# UNITED STATES PATENT AND TRADEMARK OFFICE

APPLICATION NO.	FILING DATE	FIRST NAMED INVENTOR	ATTORNEY DOCKET NO.	CONFIRMATION NO.
10/648,847	08/26/2003	Mark H. Machina	APTI:066	3853
7590 ROSSI & ASSOCIATES P.O. Box 826 Ashburn, VA 20146-0826			EXAMINER CLEMENT, MICHELLE RENEE	
ART UNIT 3641		PAPER NUMBER		
MAIL DATE 05/30/2007		DELIVERY MODE PAPER

<b>Office Action Summary</b>	Application No.	Applicant(s)
	10/648,847	MACHINA ET AL.
	Examiner Michelle (Shelley) Clement	Art Unit 3641

## **DETAILED ACTION**

**FIG. 5**

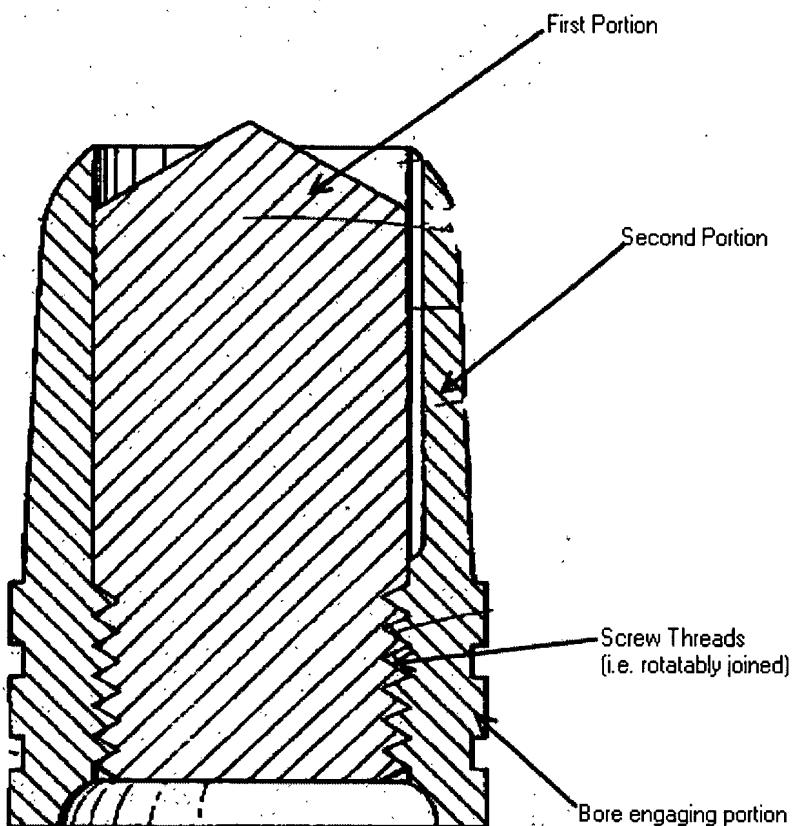
5. Claims 1-4, and 14 are rejected under 35 U.S.C. 102(b) as being clearly anticipated by Winter (US Patent # 5,160,805). Winter discloses a projectile for firing from a firing device comprising a first portion and a second portion extending from the first portion, wherein the first and second portion are rotatable joined and wherein at least one of the first and second portions is configured (i.e. has the ability to) engage a bore of the firing device. The projectile being an apparatus for displacing material from a target and including a firing device for firing the projectile and a cartridge adapted (i.e. having the ability) (reference 12) for chambering in the firing device. The second portion has less mass than the first portion (it is made of a lighter material) (column 5, lines 5-10). The second portion has a bore engaging portion. The first portion is frangible (tungsten is a known frangible material).
